ARCHITECT'S SUPPLEMENTAL INSTRUCTIONS

PROJECT: Bear Claw II Exterior Remodel
2420 Ski Trail Lane
Steamboat Springs, CO 80487

ASI NO: 008

Ski Entry existing slab damage structural repair in response to MCP RFI #012 dated 2019-06-19.

⑦ SECTION △9
ALTERNATE DETAIL
S102

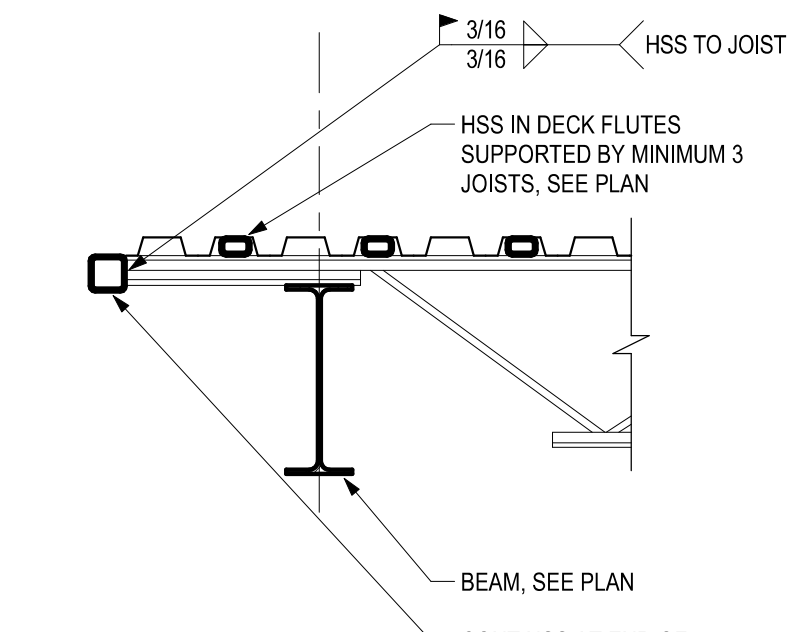
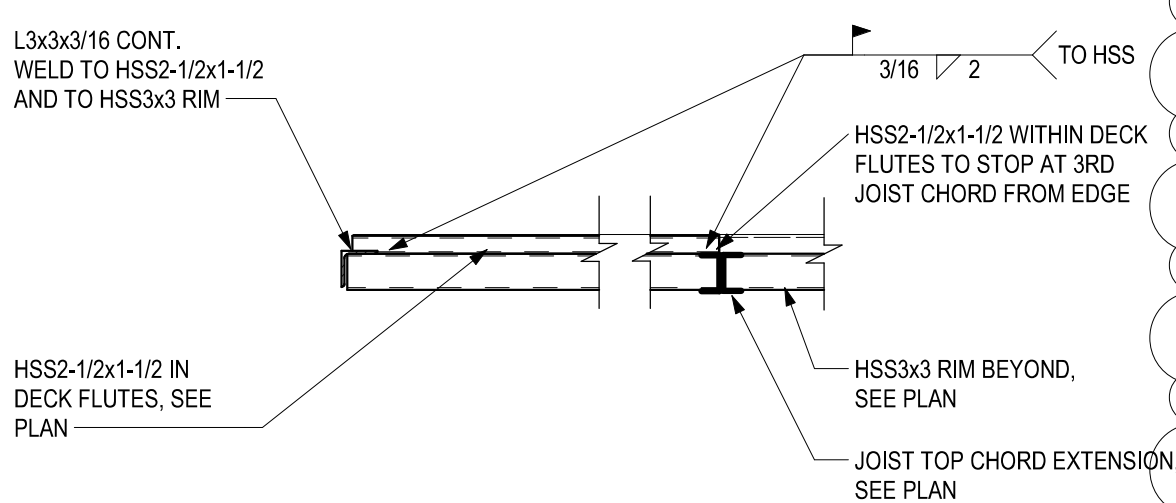
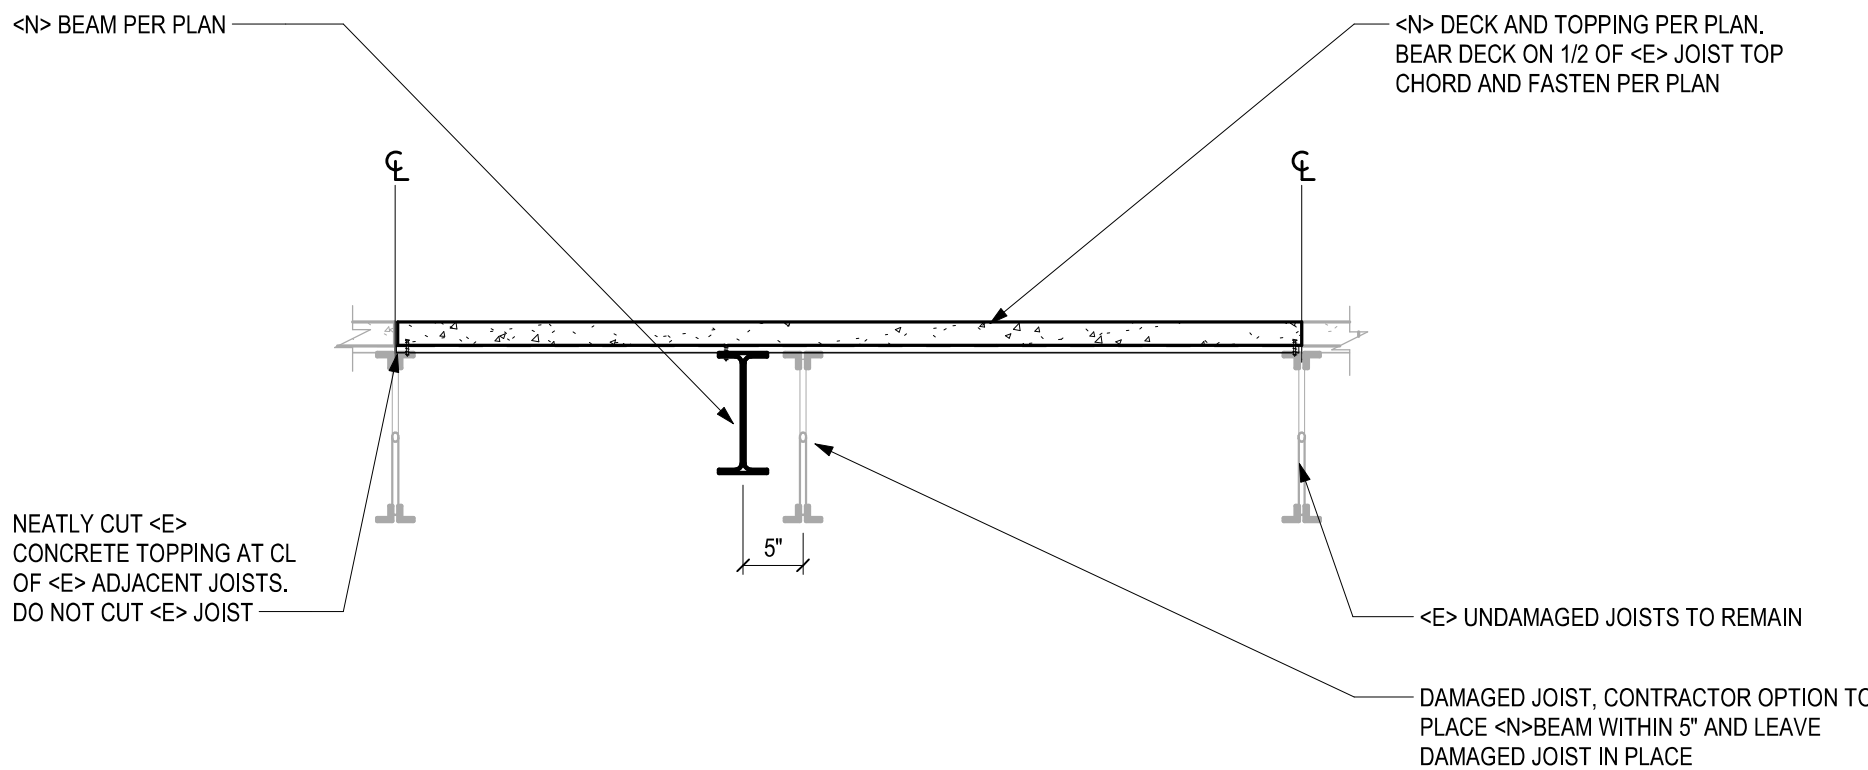
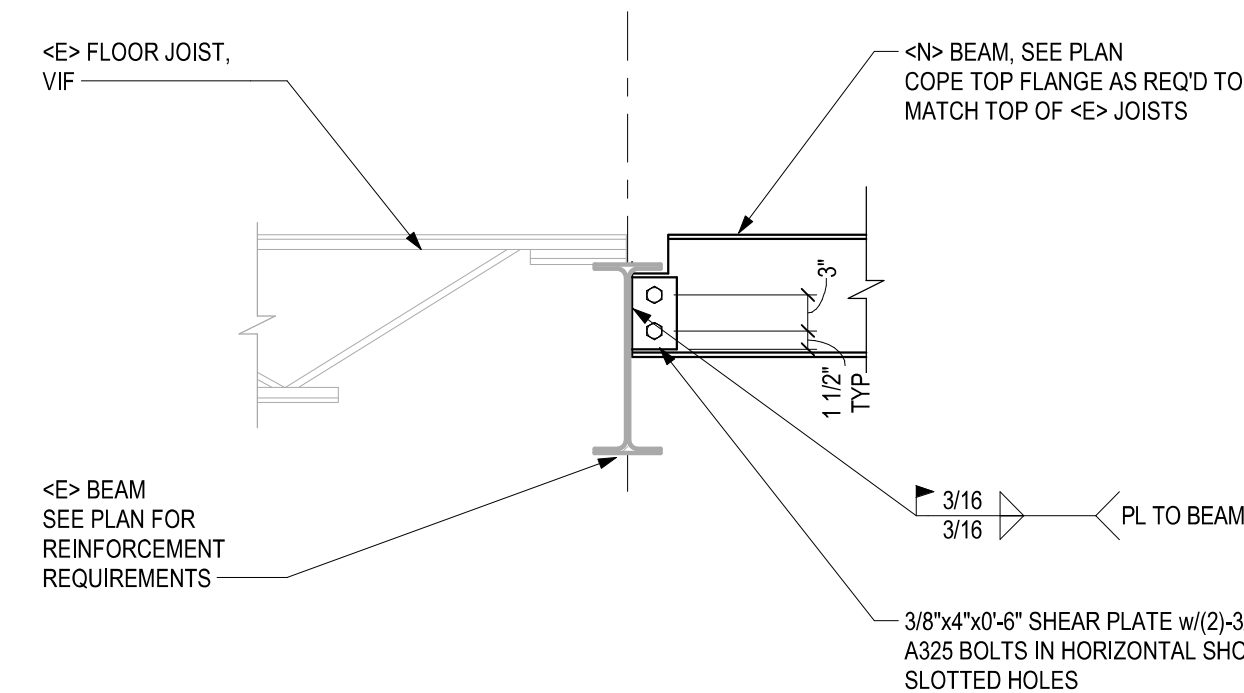
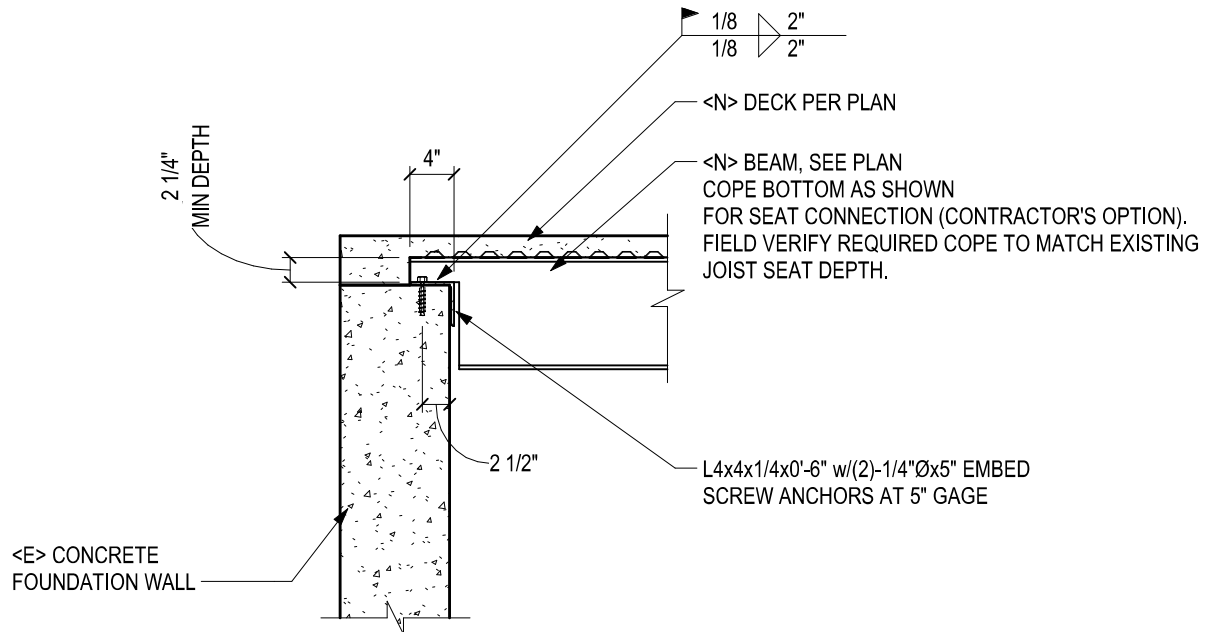
<N> BEAM, SEE PLAN
COPE BOTTOM AS SHOWN
FOR SEAT CONNECTION (CONTRACTOR'S OPTION).
FIELD VERIFY REQUIRED COPE TO MATCH EXISTING
JOIST SEAT DEPTH.

L4x4x1/4x0'-6" w/(2)-1/4"Øx5" EMBED
SCREW ANCHORS AT 5" GAGE
